MATERIALS LICENSE

Amendment No. 45

September 25, 1996

re: US NRC Region III letter from CFGill to CWSmith
dated August 28, 1996 and NRC Control # 301423.

THE UPJOHN COMPANY
KALAMAZOO, MICHIGAN

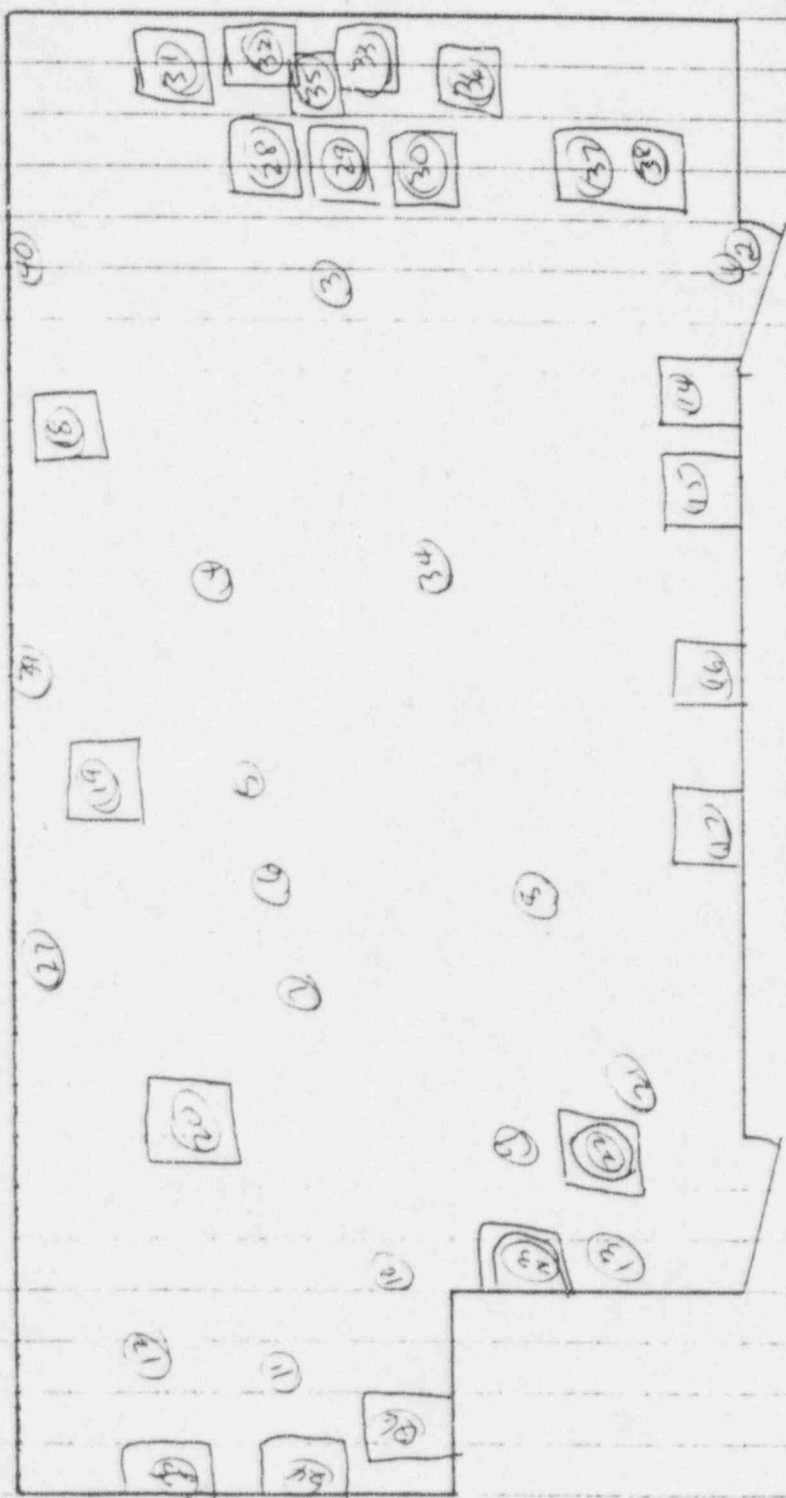
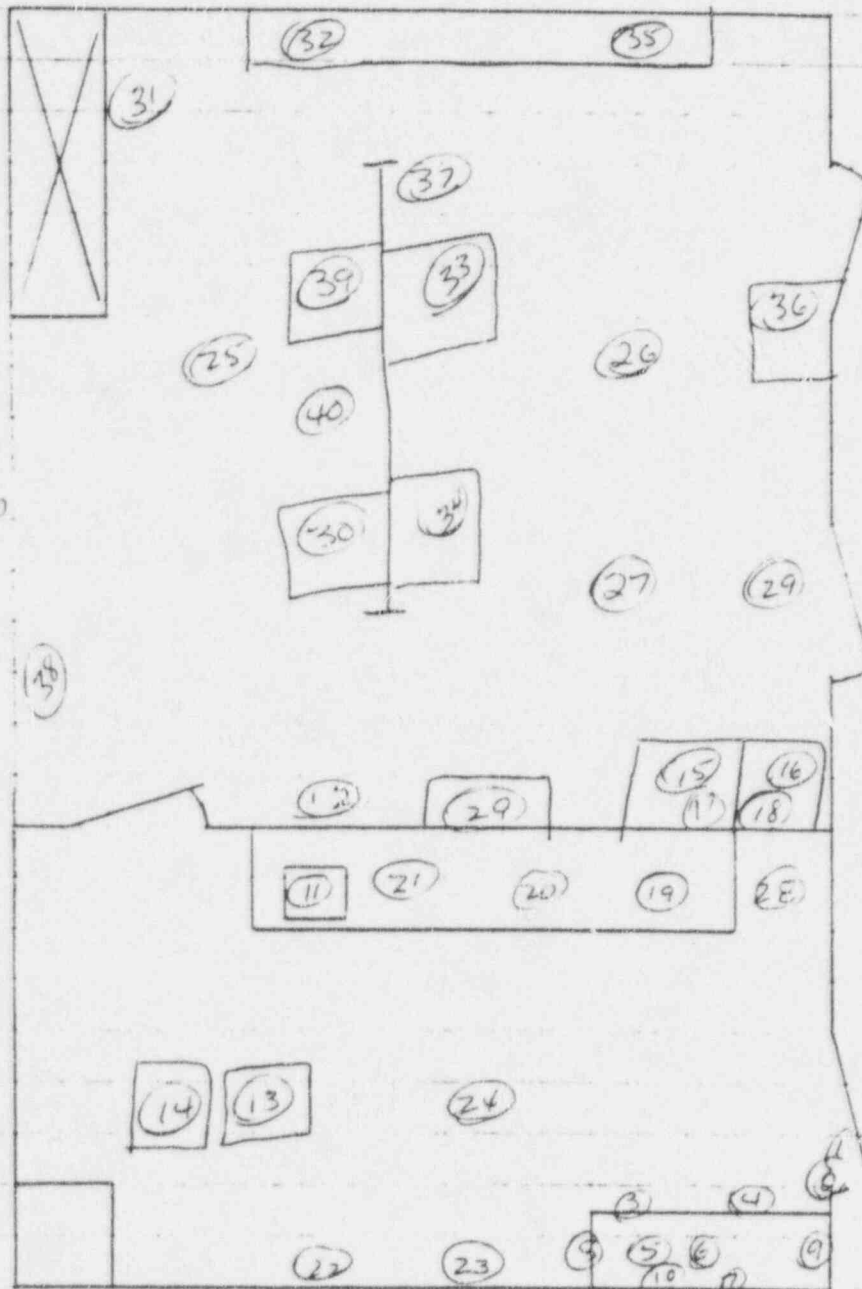
Please submit... a diagram of your old facility with survey and wipe test results keyed to specific locations. Please record your survey results using the appropriate units as described in 10CFR30.36(j)(2)(i). (Records should include) the name of the person performing the survey, the date the survey was performed, the instrument(s) used for exposure rate measurements and for analysis of the wipes, background readings, and the date that the survey instrument was last calibrated.

Appendix 3 provides the revised records of the wipe test results and direct surveys for areas in BCIU where radioactive material was used or stored. As far as can be determined, radioactive material was transported in the hallways and use in 13 specific rooms. Surveys for these areas are enclosed.
